## Certified Action of the City of Raleigh Planning Commission

**Case File / Name:** SP-40-12/ Mattress Firm at Wake Forest Rd.

**Nature of Case:** This request is to approve a single story retail use of 4,000 square feet. This site plan is situated on a 0.83 acre site, split zoned Neighborhood Business CUD and Residential 4. This is a retail use located within 400 feet of a residential use or zone.

**Proposed Site Plan**

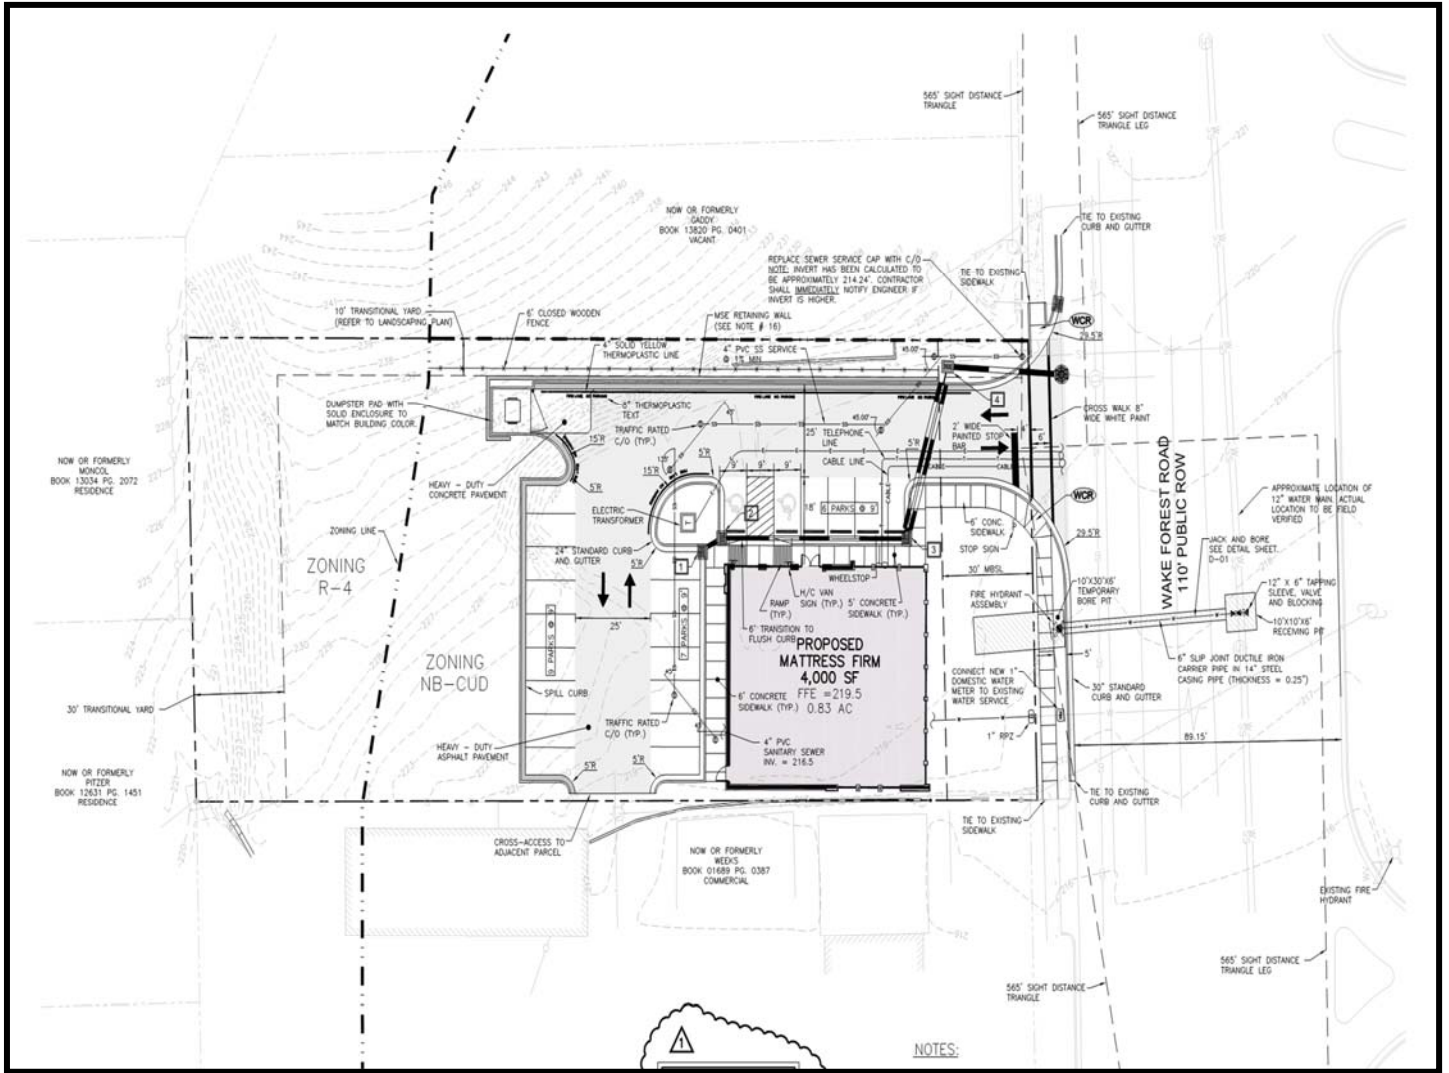
<u>Comment</u>	<u>Response</u>
1. The Commission appreciates the applicant's placement of the building at the front of the lot to help create a street wall and suggests considering additional architectural treatments to add warmth to Wake Forest Road façade.	The facade presented to the street is already "warm" in appearance. The warm earth tone EIFS colors of chocolate brown, tan, and white tie in with the Holly Park Shopping Center renovation across the street. The white wrap around "canopy" like projection above the windows provides an inviting street presence to the facade. In addition, the articulation of the storefront with thick metal column elements and decorative mullion pattern provide a unique and attractive appeal from the street.

2. The Commission suggests changes to the street yard planting including the use of a deciduous tree species instead of red cedar, such as oaks.	These trees have been modified, as suggested.

3. The Commission suggests the addition of something to improve the tall, long retaining wall such	Additional plantings have been added along this wall, as suggested.

as a cascading Carolina jasmine planted at the top of the wall.

- 4. The Commission suggests moving the wood fence at the top of the retaining wall north a bit to provide vertical relief to the perceived height of the wall and fence, and to provide room for cascading plants and the roots of shrubs and trees. As currently shown, the fence shown is 2-3 feet from the wall, providing enough room for the Carolina jasmine plantings. Moving the fence further from the wall would compromise the proposed plantings along the TPY which are required to be located adjacent to the property line.
